EPA Oral Hearing, Bracken Court Hotel, Balbriggan – 28 April 2009 (Slide 1)

Re: Fingal Landfill Project

Statement of Evidence

Consideration of landfill development – Post Management

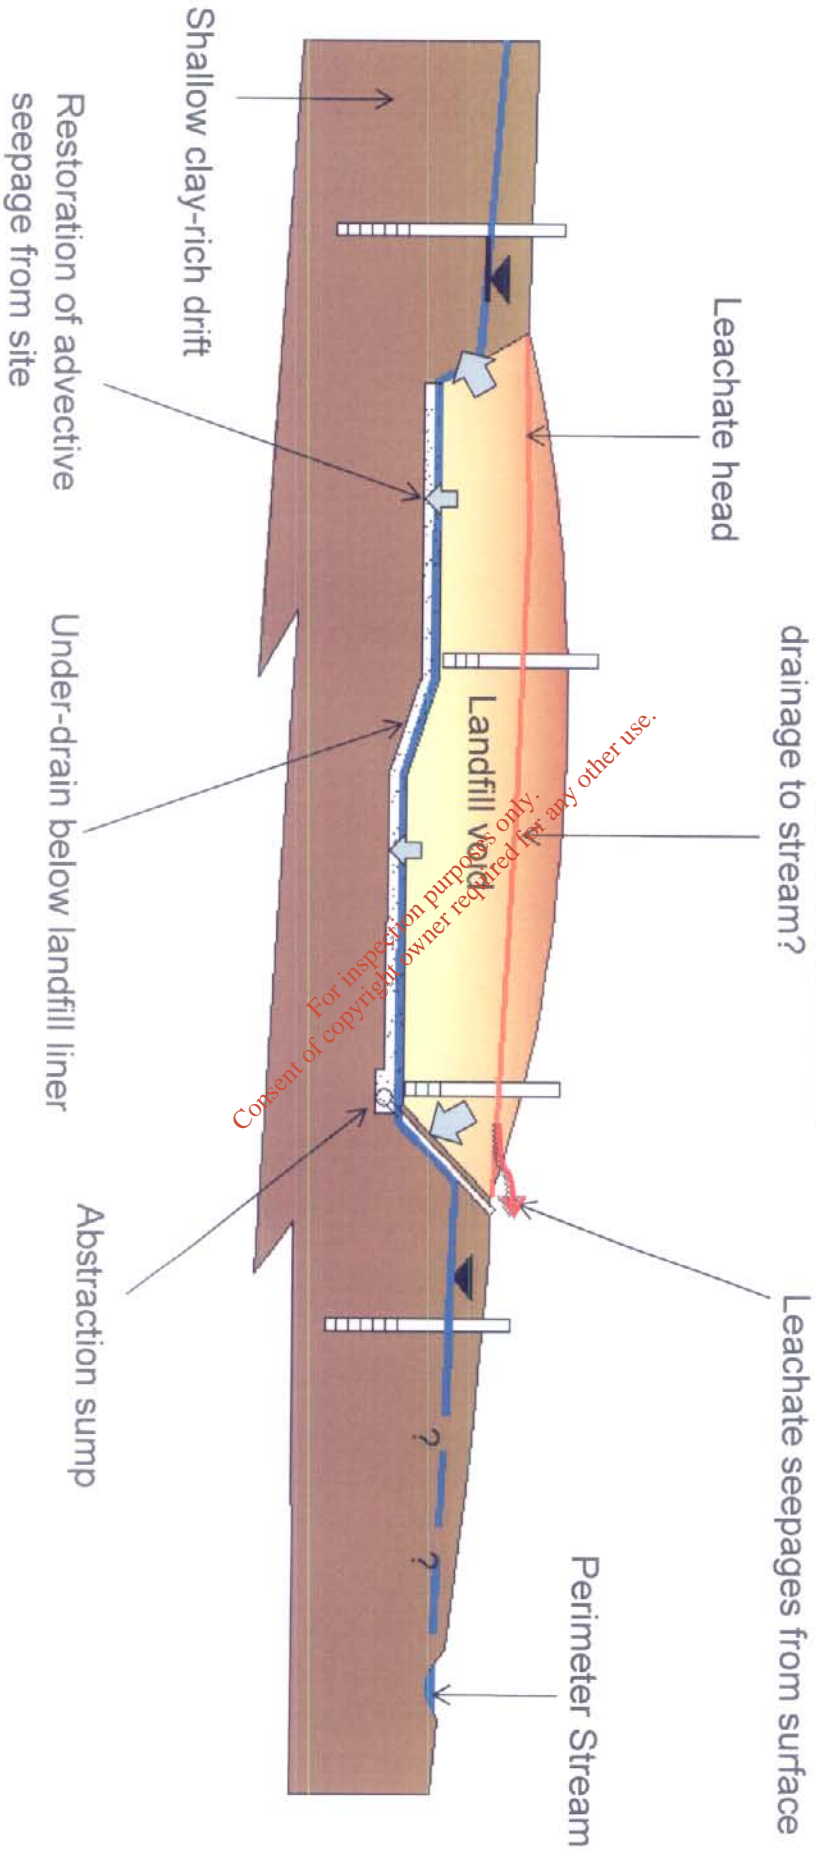
Following cessation of leachate management within the landfill, the HRA states in Section 4.2.3 that *'leachate levels would rise over-time and could potentially exceed perched groundwater levels within the clay.... Eventually a hydraulic equilibrium between leachate levels and perched groundwater would be established such that there would be no net hydraulic flux between the two and the main transport mechanism would be diffusion'*. This text differs from the actual Post Management scenarios presented on Figure 5 and Figure 006, where leachate is reported to occur by advective flow at this time.

We would expect that the leachate level within the site (post active leachate management) would be predominantly influenced by the hydraulics of the landfill including the relative performance of the cap to allow for infiltration and the liner to release leachate. In our experience of modern membrane lined landfill hydraulics, and in particular due to the fact that this site appears to be at least partially hydraulically contained with a relatively shallow waste mass, leachate levels would be expected to accumulate following termination of control until they exceed the surrounding groundwater elevation. Thereafter, breakout via the cap is anticipated, perhaps to a surface water course. As such, diffusion would not be expected to be the main mechanism driving contamination from the site at this time, but rather advective flow down a hydraulic gradient across the liner or break out flows through the restored landfill surface into perimeter surface water drains. To assume that the leachate and shallow drift water levels will remain in equilibrium is fanciful at best. (Slide 11)

Expected leachate equilibrium level controlled by surface breakout – drainage to stream?

Consideration of landfill development - Operational Phase

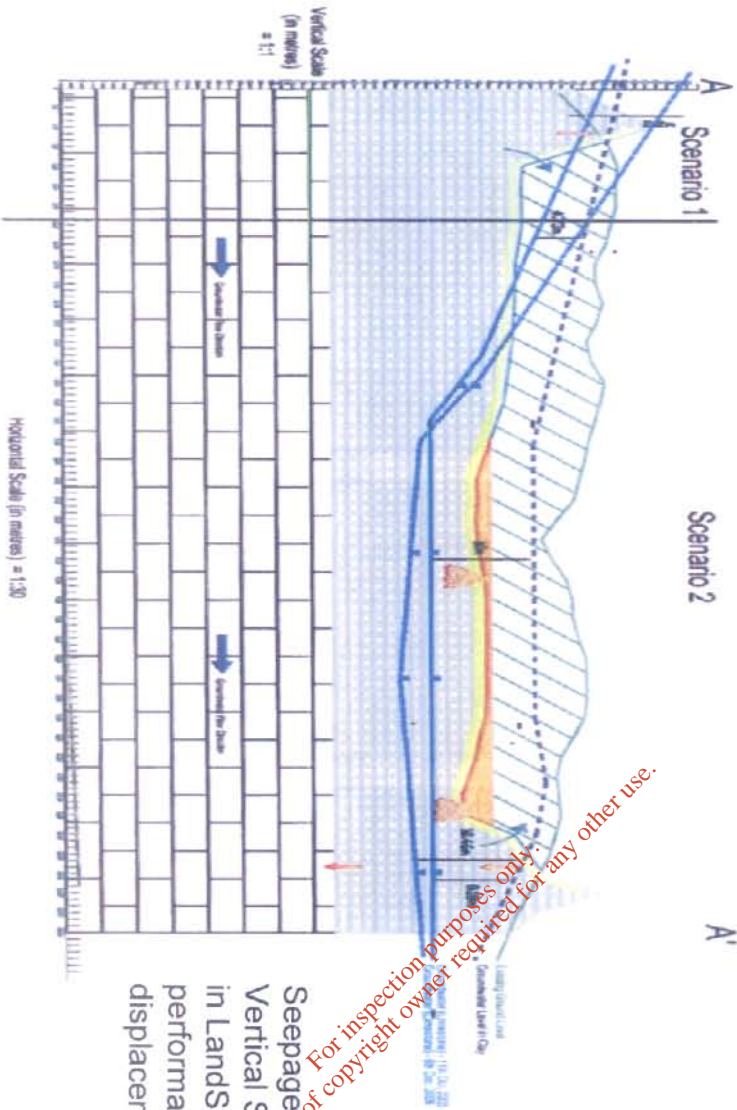
When sub-water table landfills become filled and liner stability can be assured, dewatering of groundwater on the outside of the liner is normally relaxed in a phased and controlled manner. Figure 3.18.7 of the EIS submission presents the leachate within the landfill as being hydraulically contained below both a shallow perched water table in the drift and the piezometric surface in the underlying Gravels/Bedrock. However, the Executive Summary of the subsequent HRA is less definitive (as detailed above). A greater understanding of water levels in the shallow drift is essential to demonstrate the definitive nature of the water table in this unit across the site footprint, if the entire landfill will be developed below this water table, and essentially if it will be fully hydraulically contained at any time during the landfill lifecycle. (Slide 10)

LandSim Operational Phase

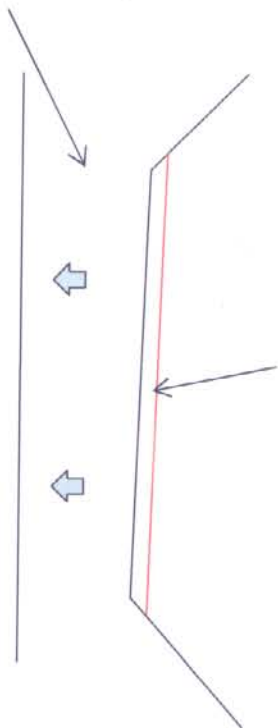
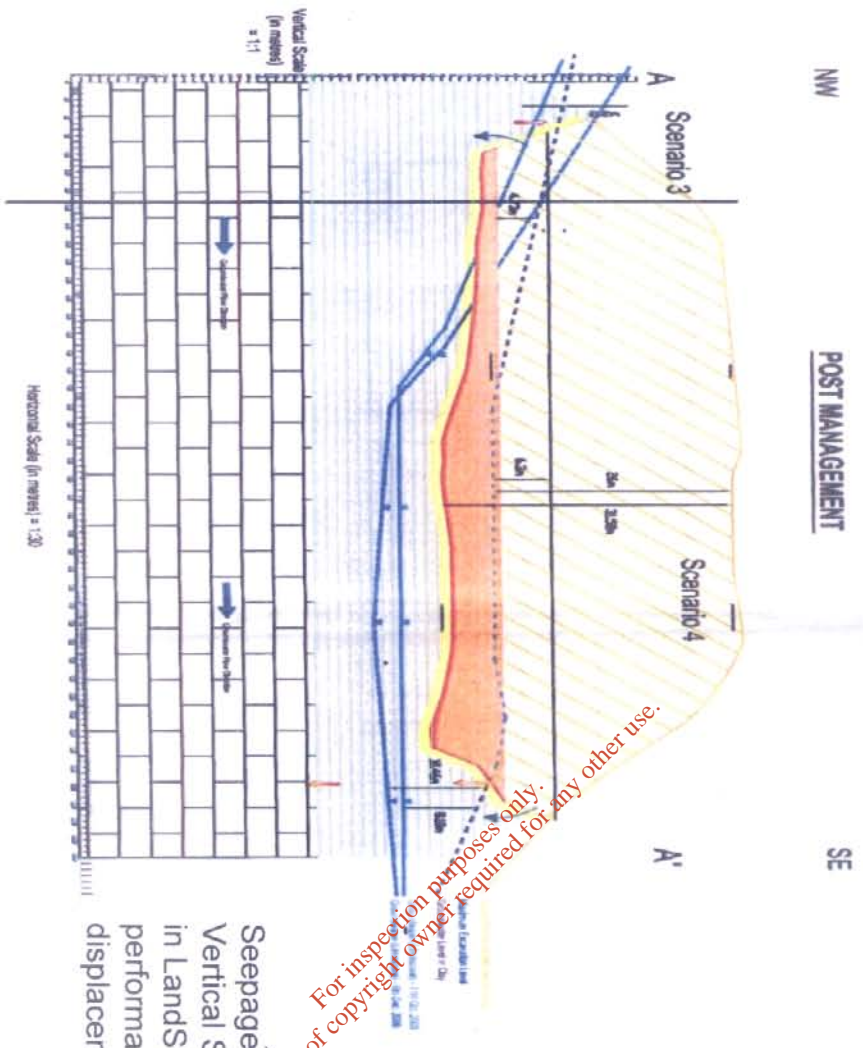
The LandSim model presented has been used to predict concentrations at the base of a 10 m clay drift column as a result of a 1 m leachate head acting on the basal liner driving leakage out of the site by advective flow. The clay rich drift has been selected to modelled by the applicant as a vertical saturated pathway within LandSim, which allows for vertical seepage migration rates below the landfill based not on natural vertical gradients, but on liner leakage rates driving full moisture displacement within this pathway. The 1 m leachate head is maintained in the model for 60 years following initial waste disposal (30 years following expected closure). Thereafter, LandSim has been used to determine the leachate level within the site based on its transient water balance capabilities and varying infiltration rates and leakage rates as a result of the assumed gradual degradation of the geomembrane in the cap and base liner over time and varying leachate heads. It is not obvious how this transient LandSim model simulates any or several of the four conceptual model scenarios presented in the HRA on Figure 006, which describes the site as being hydraulically contained during the Operational Phase and leaking on the basis of an outward differential head across the liner in the Post Management Phase. No explanation is provided to connect the conceptual model understanding presented to how this is adequately represented by various elements of the model. (Slide 12)

LandSim has not been designed for a sub-water table setting. The model determines leakage rate based on leachate head and liner properties, and no account is taken of any hydraulic head on the outside of the liner. Notwithstanding the above, it is unclear when and for what duration within the landfill lifecycle the above set of simulated conditions will occur and how they have been incorporated within the simulations undertaken. Clearly at some points during the life cycle, any

1m leachate head maintained
In site for 60 years

Seepage rate through
Vertical Saturated Pathway
in LandSim driven by liner
performance and moisture
displacement

Aquifer pathway described
By Darcy's Law
